PRCOM20224906

REVISDE 6/22/2023

I-470 BUSINESS & TECHNOLOGY CENTER, LOT 7

ISSUED FOR PERMIT OWNER REVISIONS

SITE UTILITY PLAN

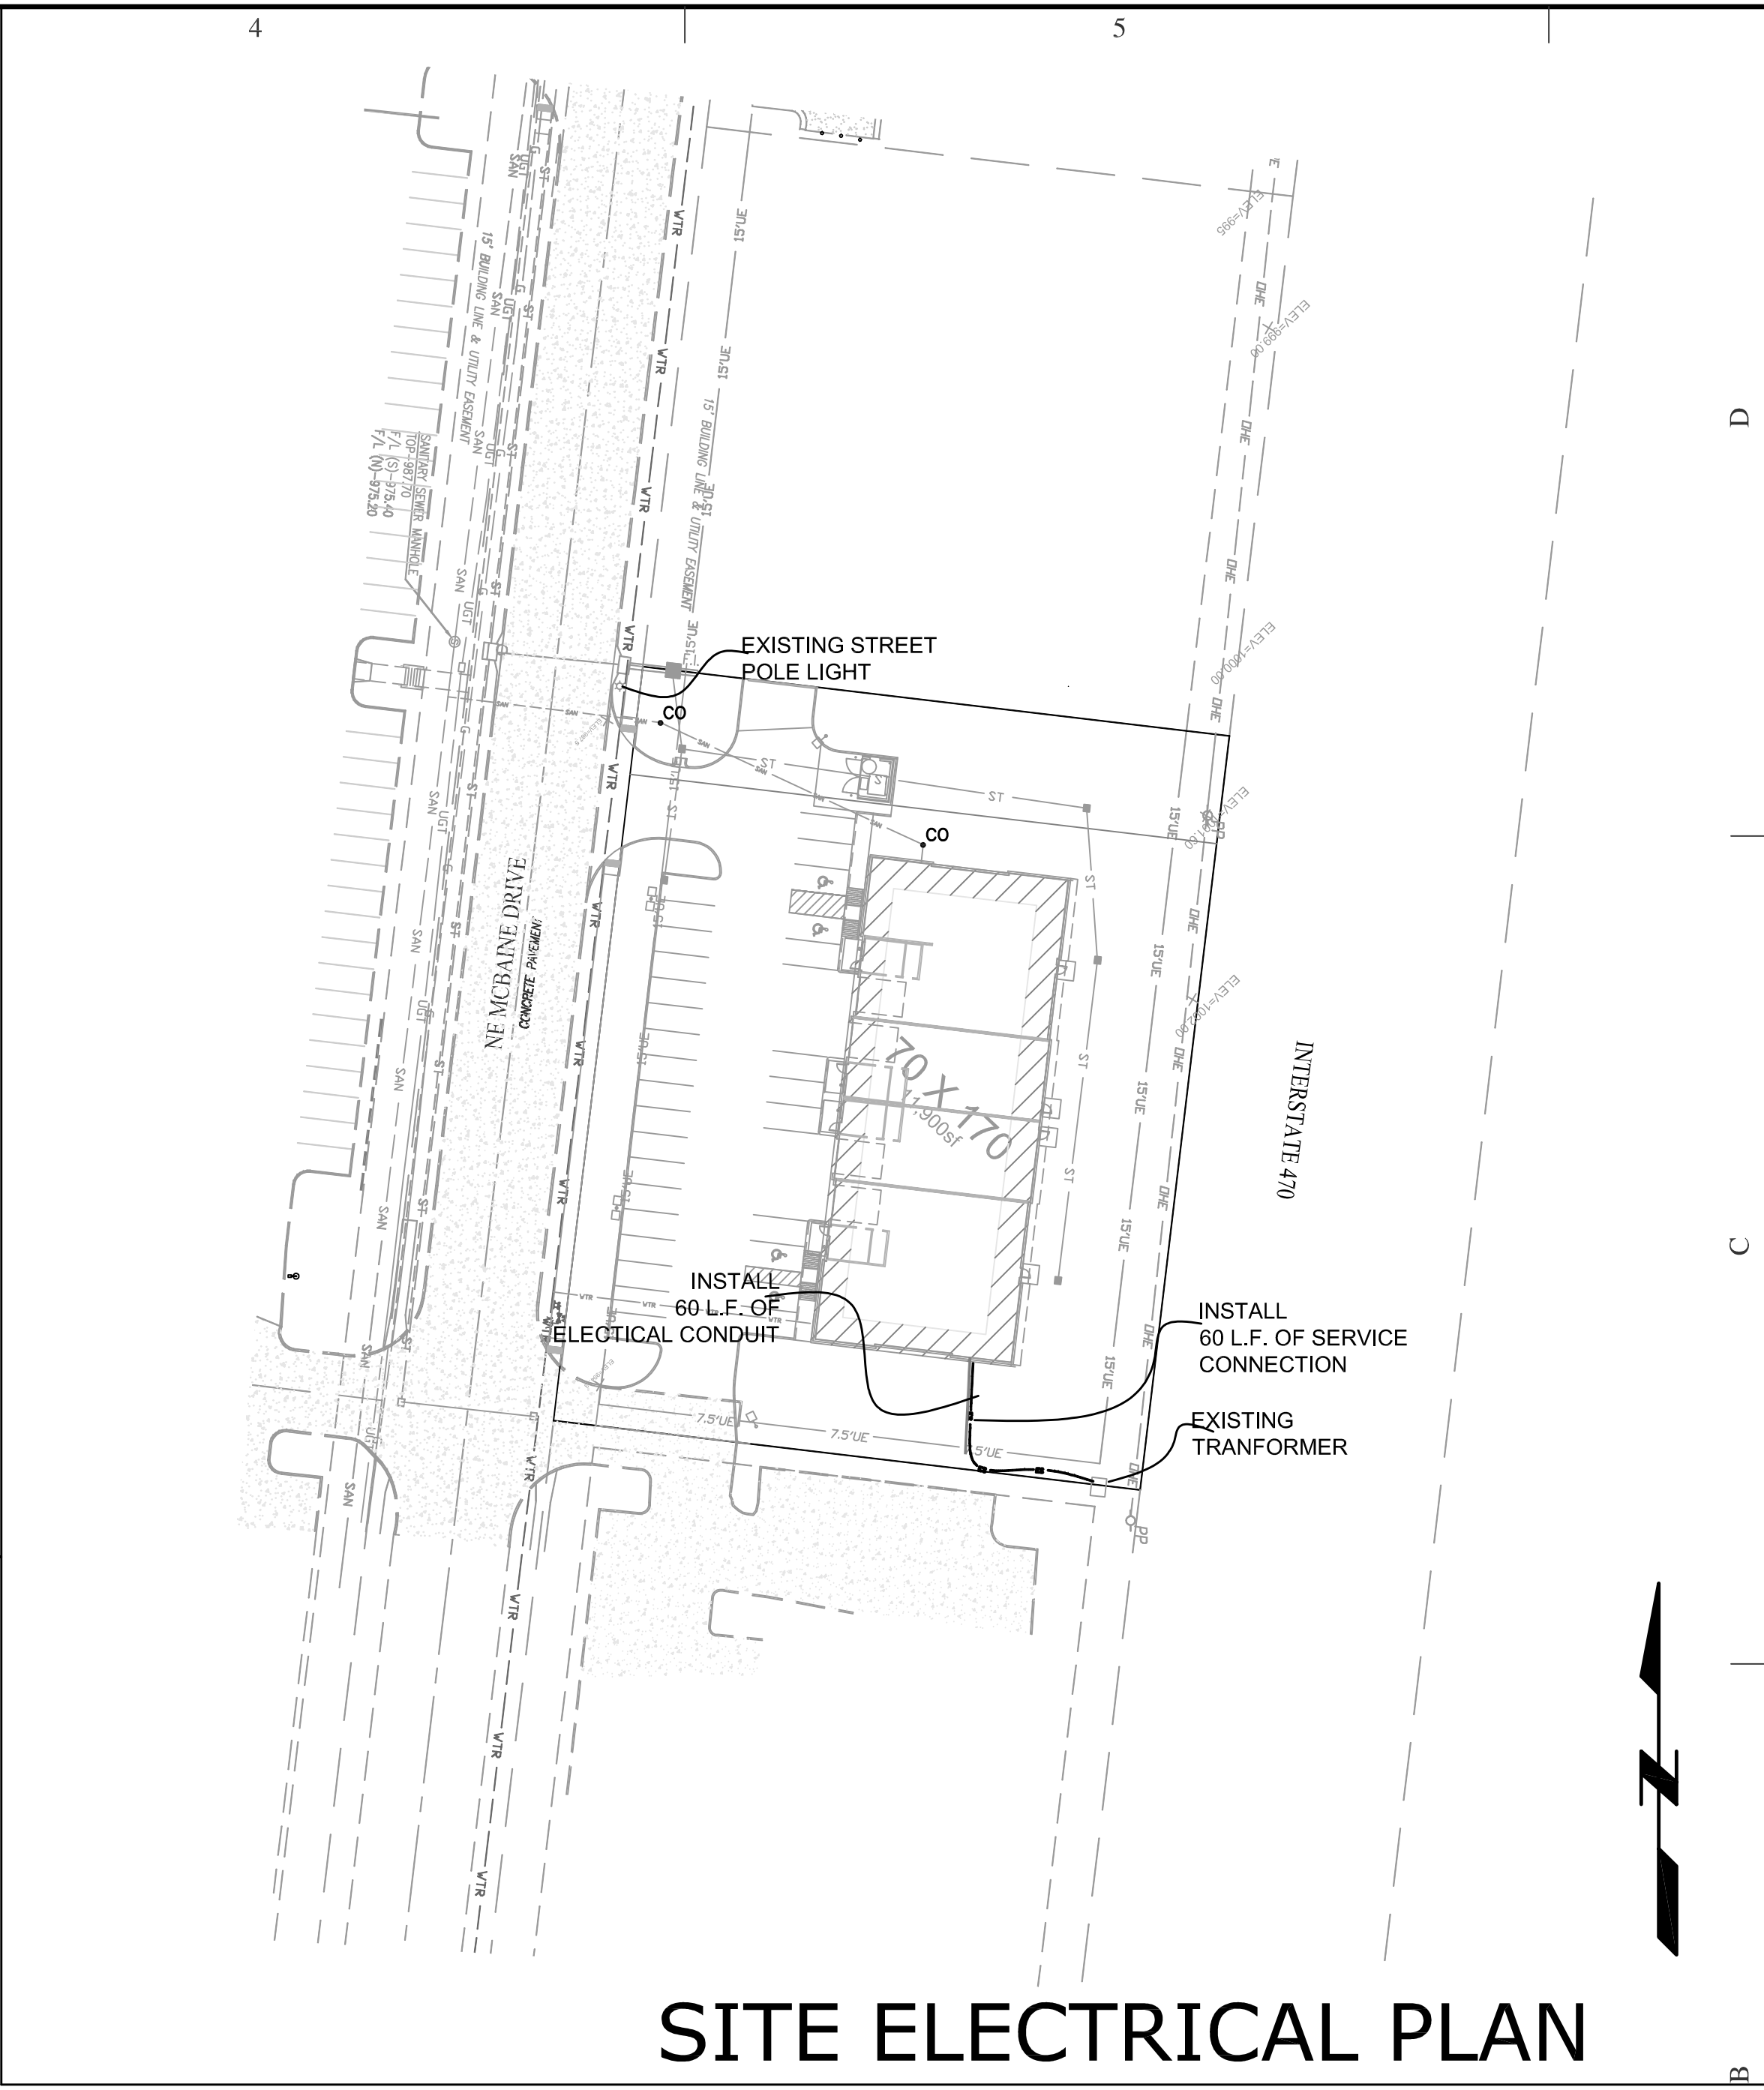
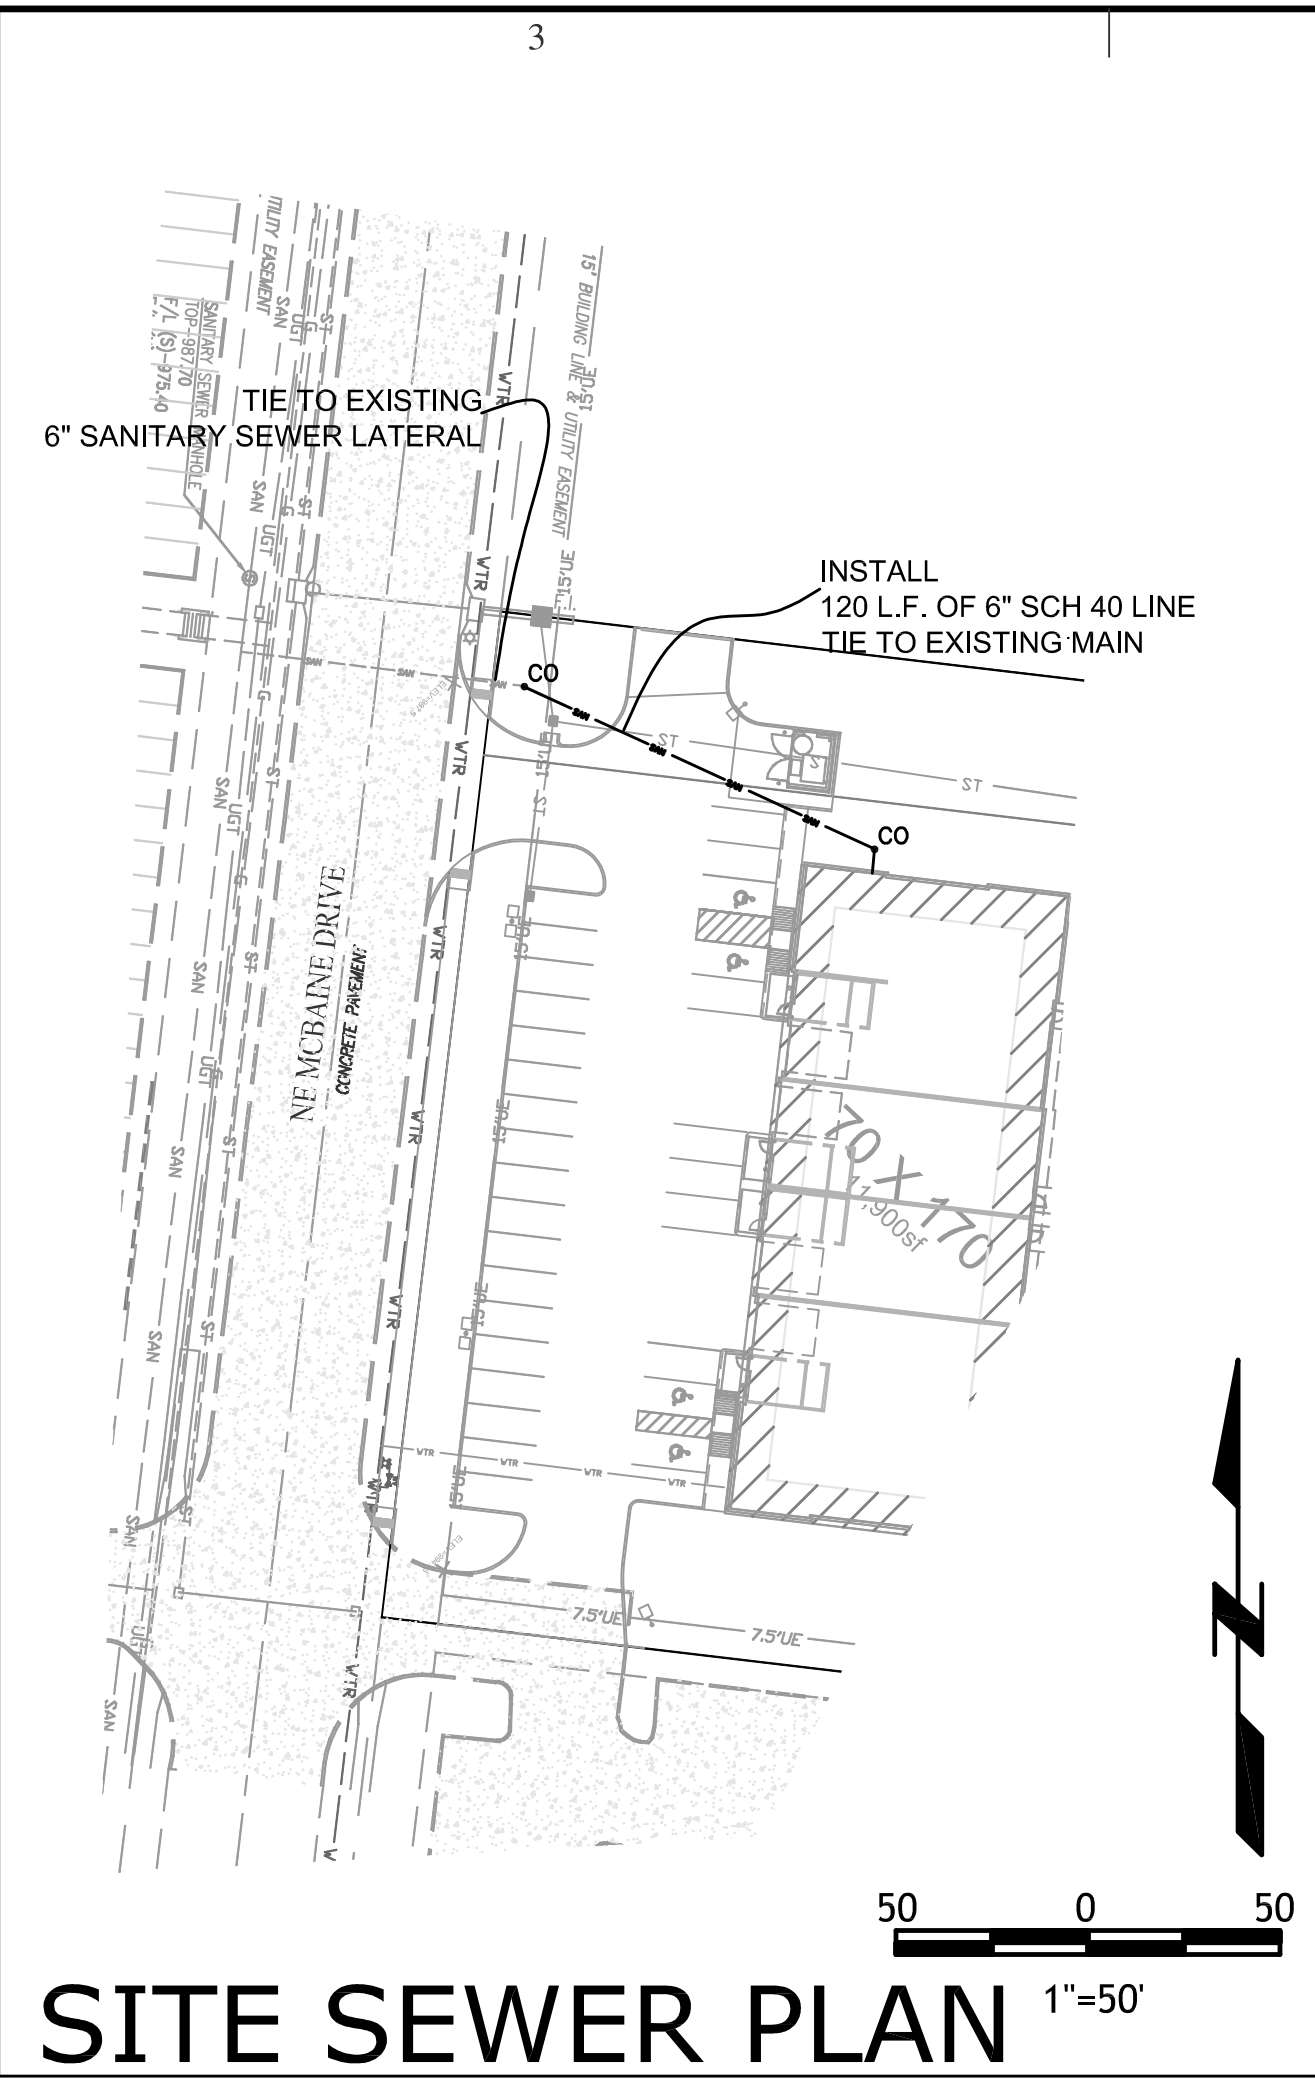
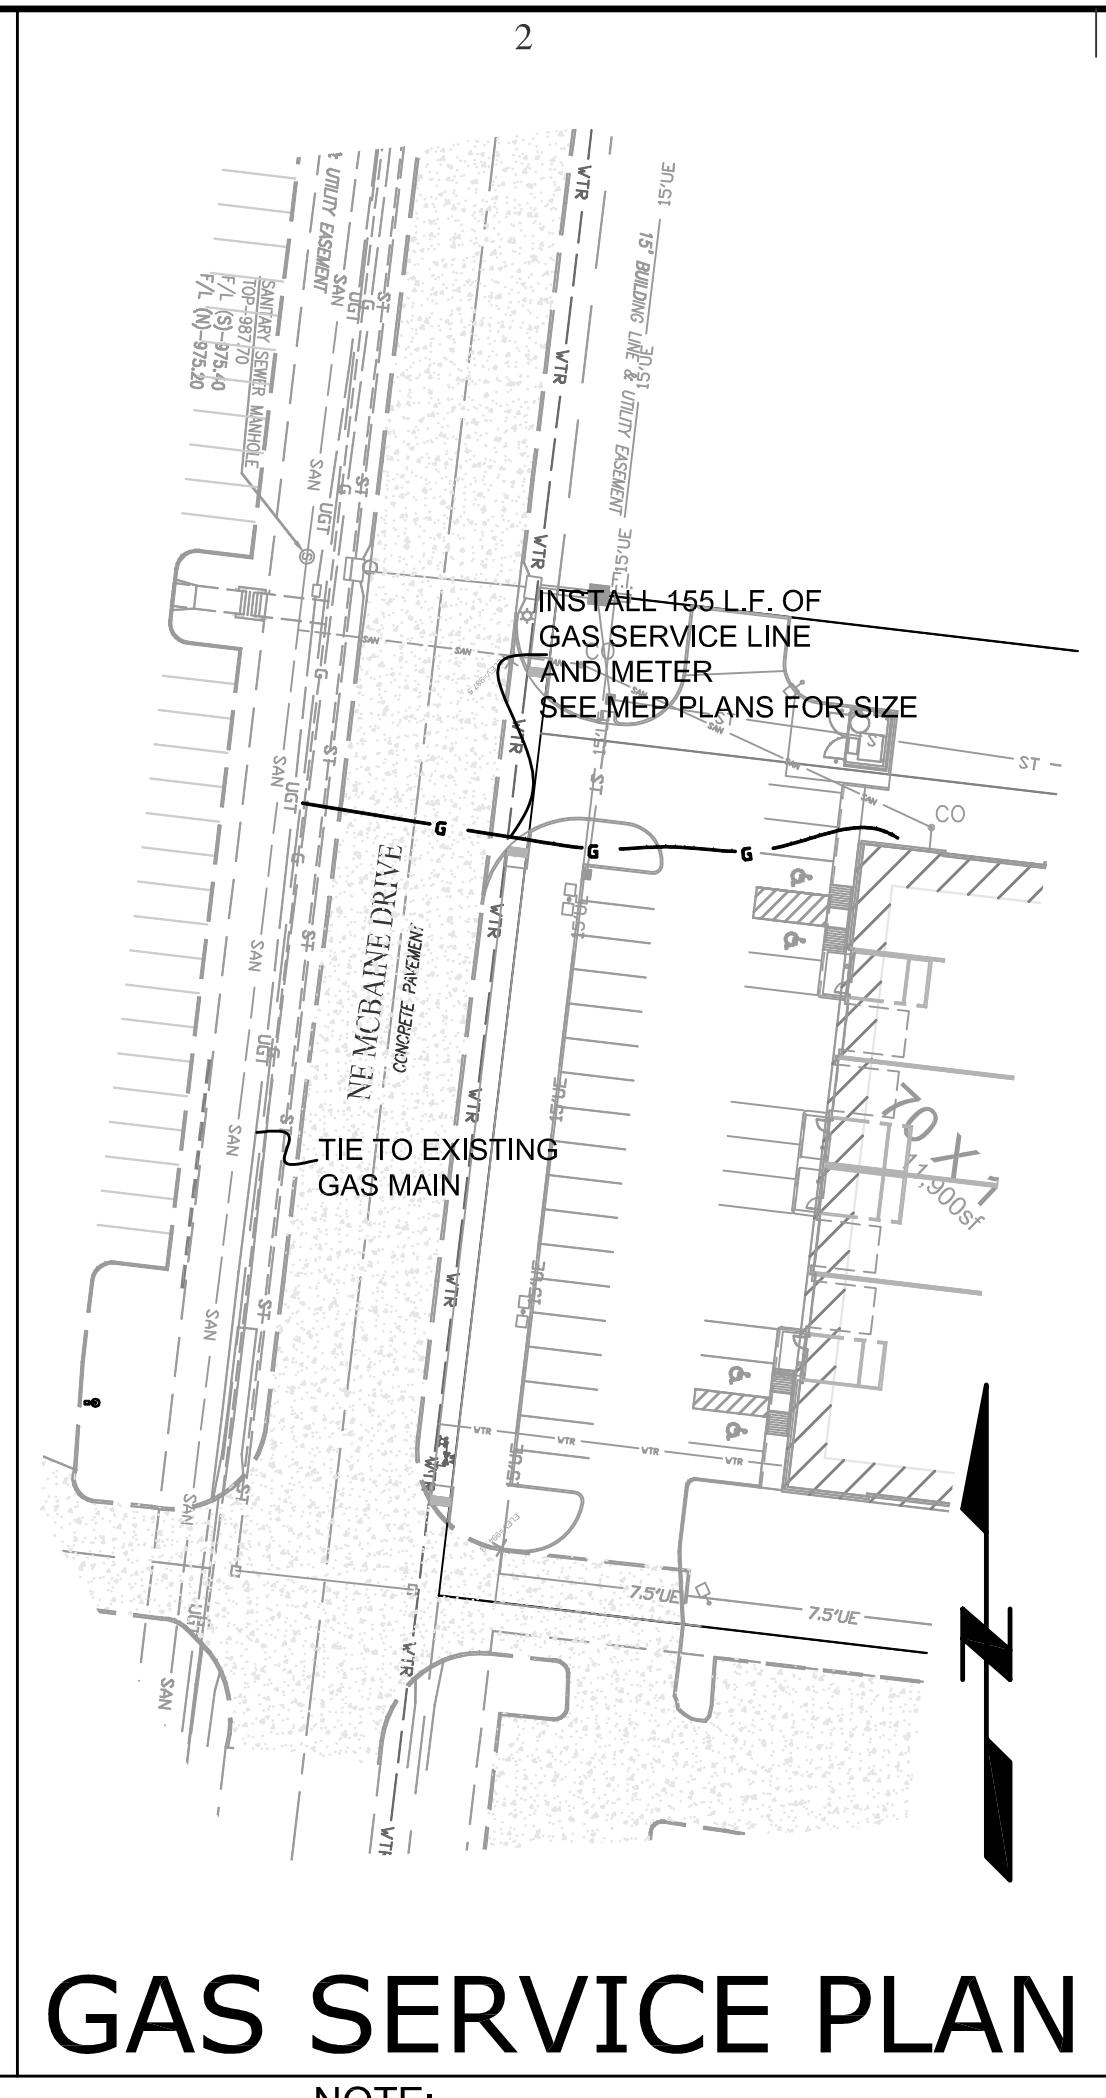
△ 6-22-23 - REMOVED REAR ACCESS ROAD, RELOCATED TRASH ENCLOSURE REVISED PARKING ALONG FRONT OF BUILDING

- △ ADDED LINE MATERIAL 12-14-22
- △ REMOVED FIRE LINE 11-17-22
